<b>To:</b>	Russell Thorne (Project Manager) RPS Pty Ltd c/- EDQ Urban Development	<b>From:</b>	Trent Williams Principal Transportation Engineer
<b>Project/File:</b>	Q168723	<b>Date:</b>	12 May 2022
<b>Department:</b>	Transport Engineering	<b>Rev. No.</b>	01

**REFERENCE: Parkside Yeronga – Community Centre****PREAMBLE**

**Reference: PARKSIDE YERONGA - COMMUNITY CENTRE PROPOSAL**

**Figure 2: Yeronga Community Centre Pedestrian Connections**

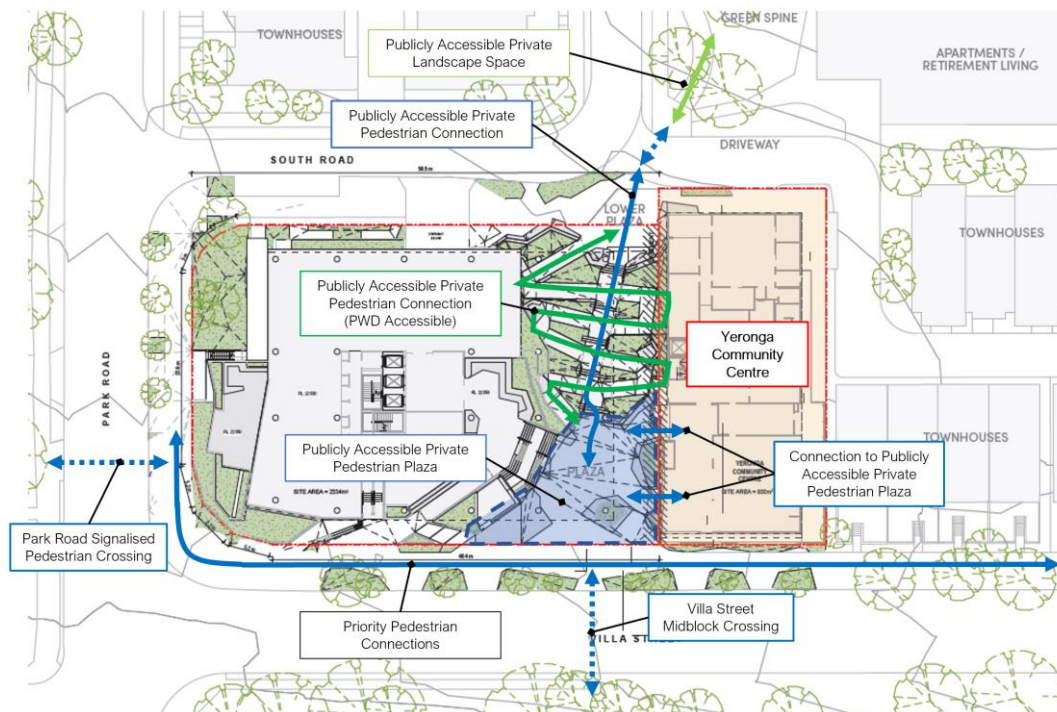
The public plaza and 'green spine', adjacent to the western boundary of the YCC, is a high-quality pedestrianised environment which is the major pedestrian connector for the Master Plan as it provides access to a multitude of transport generators within Yeronga including nearby train stations, bus stops, schools, parks, commercial and retail land uses. This pedestrianised area facilitates access from South / East Street (internal) to Villa Street (External) in which a high-quality signalised pedestrian crossing is provided on the northern approach of the Villa Street / Park Road Intersection whilst pedestrian refuge crossings are provided on the other approaches. Furthermore, a mid-block zebra crossing is provided along Villa Street to the East to allow pedestrians to cross between the Yeronga High School and Yeronga Tennis Centre.

It is noted that the vehicle access to East Road is to be designed to prioritise pedestrian walking along the Yeronga PDA internal pedestrian network. This is proposed to be achieved through the provision of surface treatments (e.g. coloured pavements, cobble stones) in discrete locations, line marking (give way line marking prior to pedestrian footpath crossing to reinforce pedestrian priority) and signage to reinforce these arrangements if required. It is recommended that the adjacent pedestrian crossing is redesigned as part of the Master Plan to incorporate queuing for one vehicle length between the stop line and the pedestrian crossing to allow vehicles to queue and wait for pedestrians to cross. Details of these treatments are currently being refined and will be provided once available (to be prepared and provided by others) as part of the Pedestrian Crossings - Compliance Assessment.

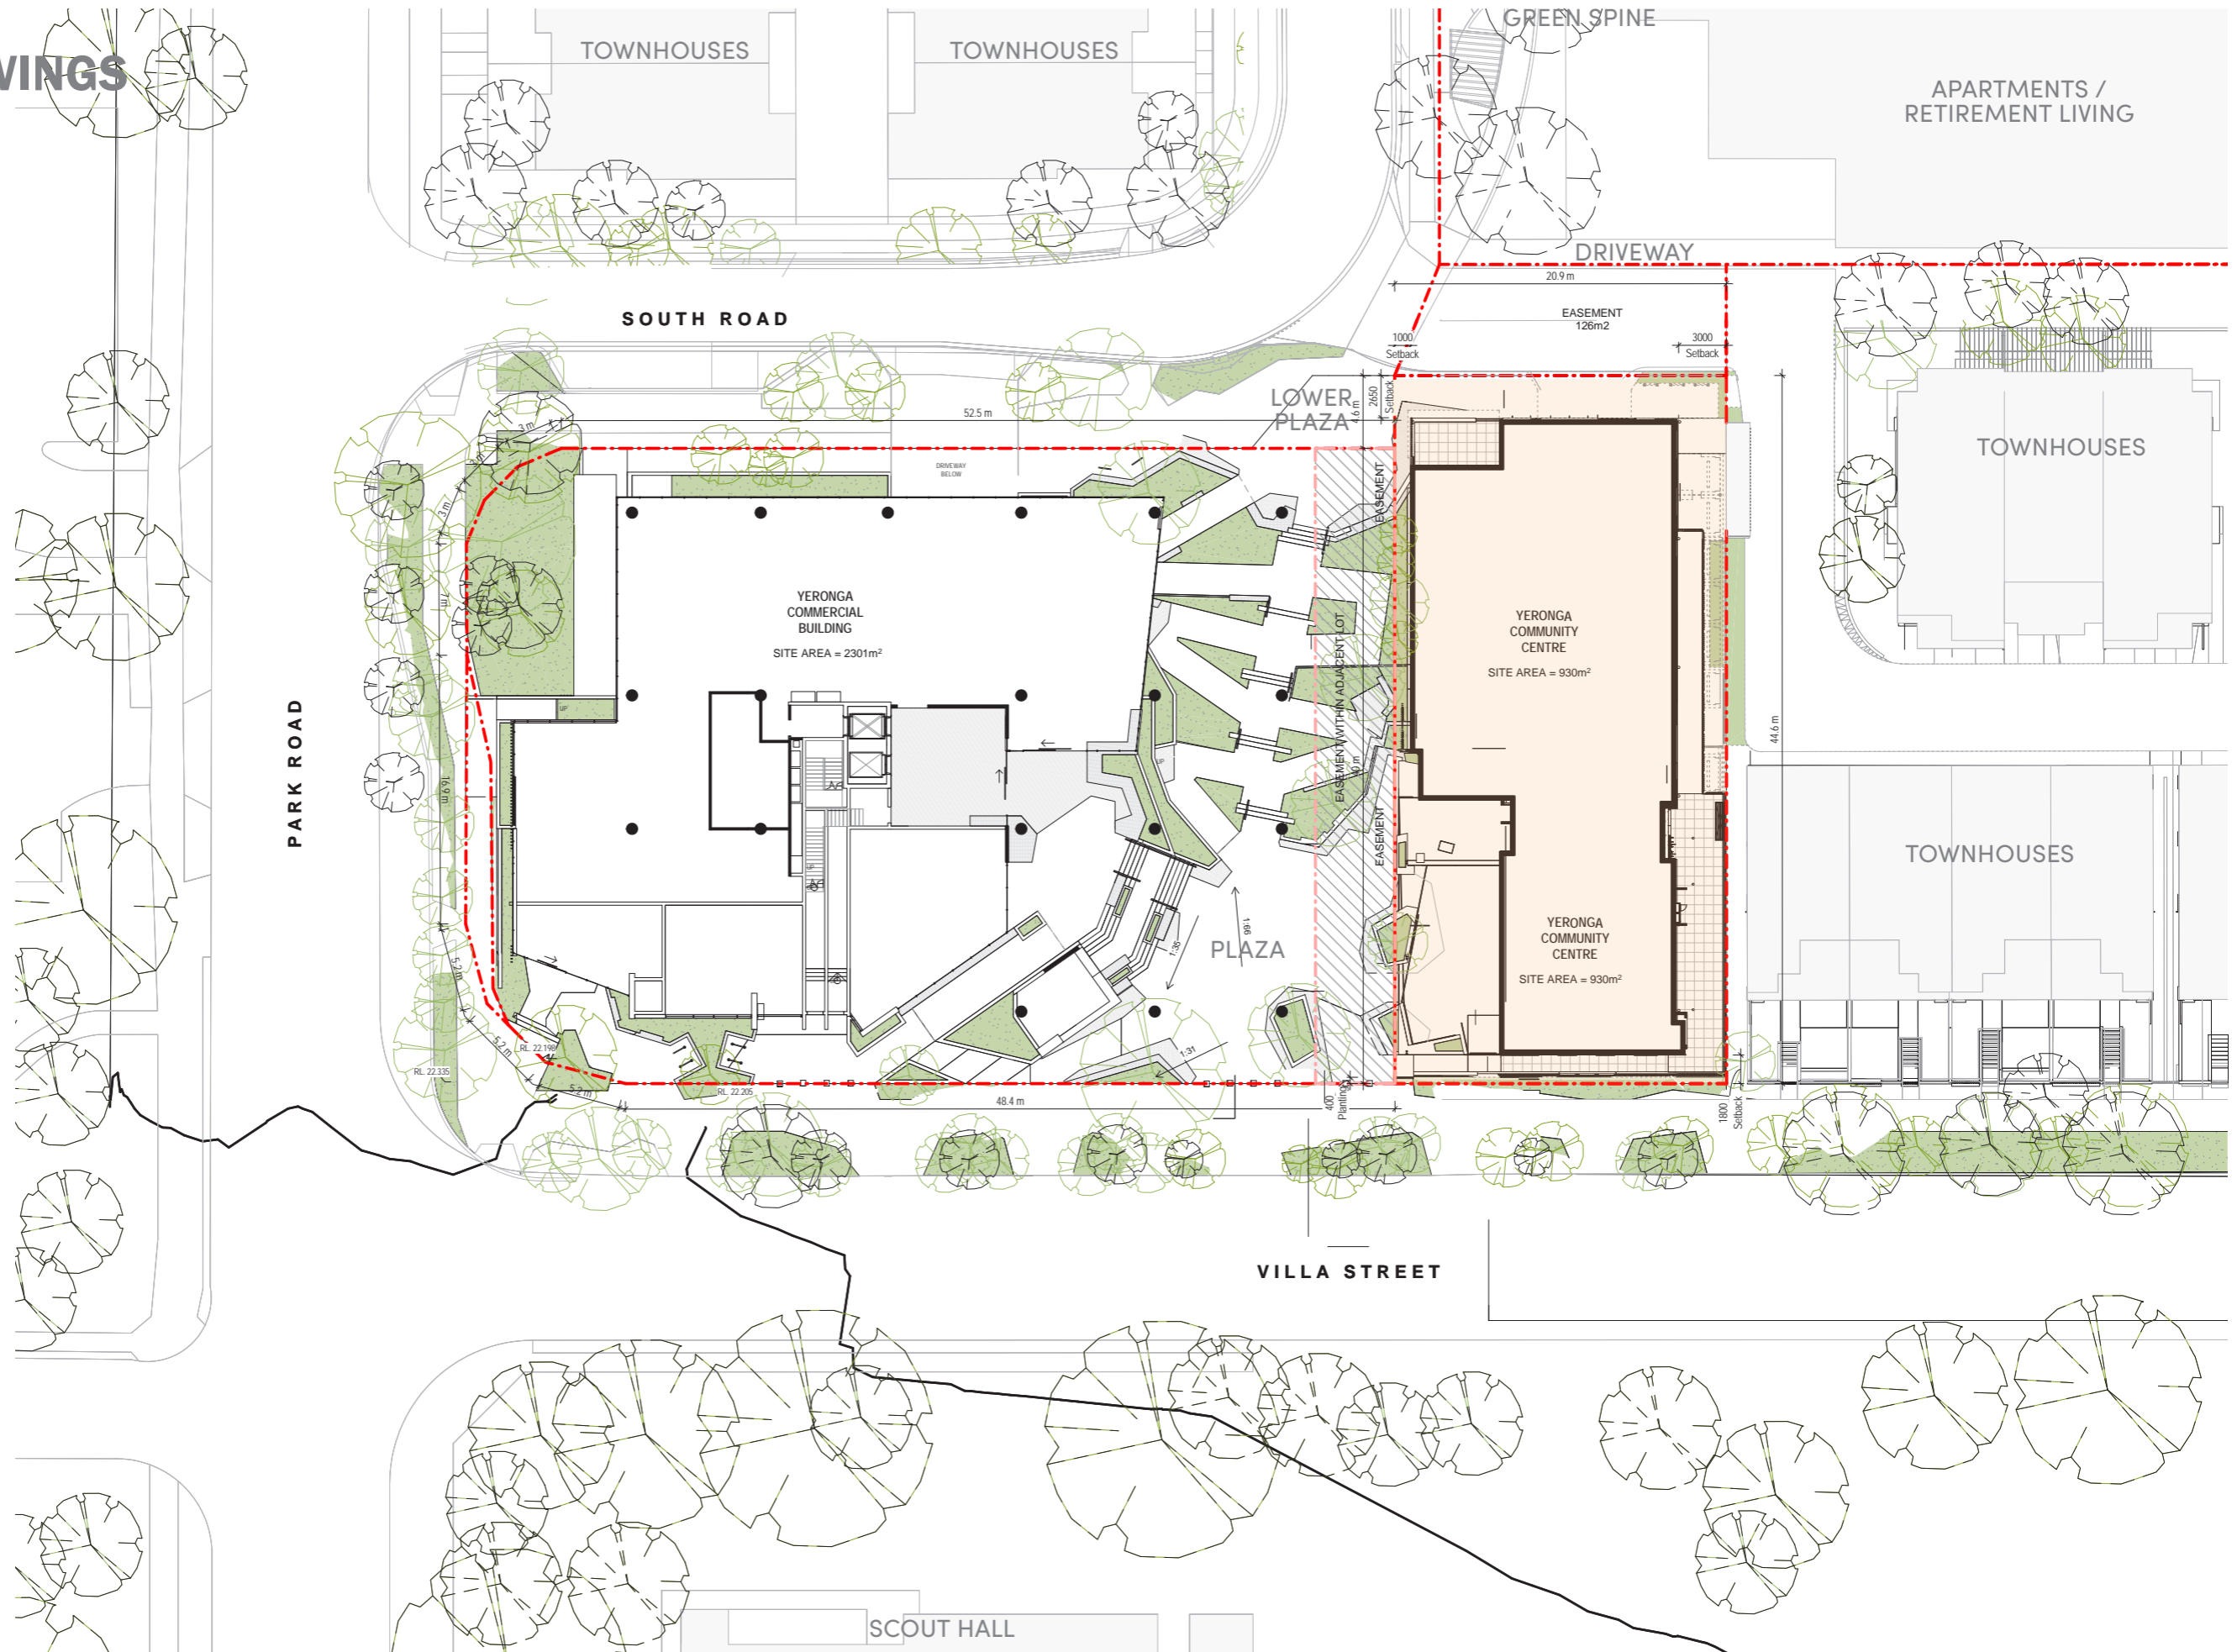
<b>INTERFACE WITH EASEMENT 7, 12 AND LOT 10</b>			
<b>T17</b>	The design of the access road on Easement 7 and 12 and Lot 10, has two tight 90 degree turns in close proximity and does not appear to show appropriate line marking in accordance with the MUTCD.	Provide a line-marking and signage plan demonstrating that the road alignment is suitably designed in accordance with the MUTCD.	This is to be addressed as part of the Development Application for Lot 10, noting that the 90-degree bends and sight distance have been provided in accordance with Council's TAPS PSP and the Austroads Guidelines (in the event that it is a shared zone).
<b>CYCLIST AND PEDESTRIAN FACILITIES</b>			
<b>T18</b>	The proposed design should demonstrate the provision of bike spaces for use by both the public and staff. It is also recommended that End of Trip facilities be considered in the proposed design to support all active transport users (including pedestrians) travelling to the site.	Provide amended plans with provision for 3 bicycle parking spaces within a publicly accessible location for use by visitors, and 6 bicycle parking spaces provided within the secure parking area for use by staff. End of Trip facilities should also be provided and indicated on the amended plans.	Refer to updated architectural plans provided in Attachment B.

Item	Context	Recommended Actions	Stantec Response
<b>T19</b>	The bench seating and planting on the north-western corner of the development appears to create a pinch point in the footpath.	Demonstrate by providing a dimensioned plan that sufficient footpath width is maintained for the whole development.	Refer to updated architectural plans provided in Attachment B.
<b>T20</b>	Figure 2 – Assessment of Villa Street has not been included in Landscape Assessment Report.	Provide amended Landscape Assessment Report which includes Figure 2. Assessment of the pedestrian and cycle capacity to Villa Street verge should also be addressed.	Refer to Landscaping Report.
<b>BCC COMMENTS ON TRAFFIC AND TRANSPORT</b>			
<b>T21</b>	Council acknowledges that the proposed aisle width of 5.8m is acceptable as per AS2890.1 as the community centre will be used by the public, however, a 6.2m aisle width is desired by Council. Further, the aisles are to provide access to PWD car parking spaces. It is suggested that the proposed convex mirror at the driveway entrance is carefully further assessed.	Provide amended plans which show the following: <ul style="list-style-type: none"> <li>• A 6.2m aisle width, with the aisles to provide access to PWD car parking spaces.</li> <li>• reversing of RCV for refuse collection. Reversing into a highly pedestrianised area is a high risk, especially for the proposed vulnerable user group. Council recommends contacting Council's Waste and Resource Recovery Services to obtain further advice on this matter.</li> <li>• Justification for the proposed convex mirror at the driveway entrance.</li> </ul>	<p>Please refer to our response to T2 with respect to the aisle width. We appreciate Council's acknowledgment that this is 'acceptable'.</p> <p>It is noted that the proposed reversing movement for refuse collection for YCC and Lot 10 was proposed as a direct response to engagement between the projects Waste Management Consultant and Council's Waste and Resource Recovery Services team. Updated refuse collection arrangements are to be detailed as part of a Waste Management Plan (prepared by others) and this can be delivered by a suitably worded Approval Condition.</p>
